SUBJECT: Part 21 rept re unusual wear pattern found on mating idler gear in DSRV Enterprise standby DG sys. Caused by incorrect machining by supplier. Vendor will change critical characteristic worksheet & add quality insp plans.

TITLE: Part 21 Rept (50 DKT)

Enterprise
Report #163

02-425-03-AB
JACKET WATER PUMP GEAR

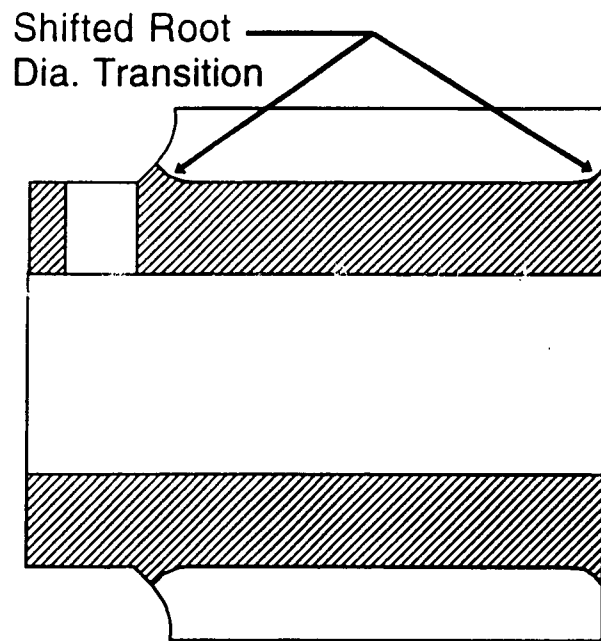
Duke Power Company reported on February 26, 1993, that subsequent to their recent replacement of the 02-425-03-AB gear per Cooper 10 CFR 21 letter #158 dated October 29, 1991, an unusual wear pattern was found on the mating idler gear. The wear pattern was described as two lines of contact on the idler gear that corresponds to the gear tooth ends of the water pump drive gear. The inspection at Duke Power indicated that the teeth on the new pump gear was noticeable shallower at the ends than the old gear previously removed.

Further investigation by Cooper with its supplier, The Gear Works, has revealed that root cause is a result of incorrect machining by the supplier, in that the root form is shallow at the ends of the gear tooth which would cause the wear pattern as described by Duke Power (see attached sketch). Our investigation of this deficiency was completed on March 8, 1993.

The gears which have been manufactured incorrectly are identified by the part number 02-425-03-AB with "Rev. C" or "Rev. D" stamped. These gears were manufactured by The Gear Works after 6/20/90.

Corrective actions by our supplier are to correct machining procedures on replacement gears to ensure the correct tooth form over the entire length of the gear. In addition, Cooper will change critical characteristic worksheets and add to quality inspection plans to include this gear tooth feature.

Corrective action by our customers should be replacement of this gear in a scheduled manner based on the availability of acceptable replacement parts. Until these are replaced, idler gears should be visually inspected monthly through the available gear case openings.

Gears/assemblies in customer storerooms should be returned to Cooper for replacement/rework/inspection. Replacement/ rework gears shipped by Cooper will be identified as 02-425-03-AB, Rev. E.
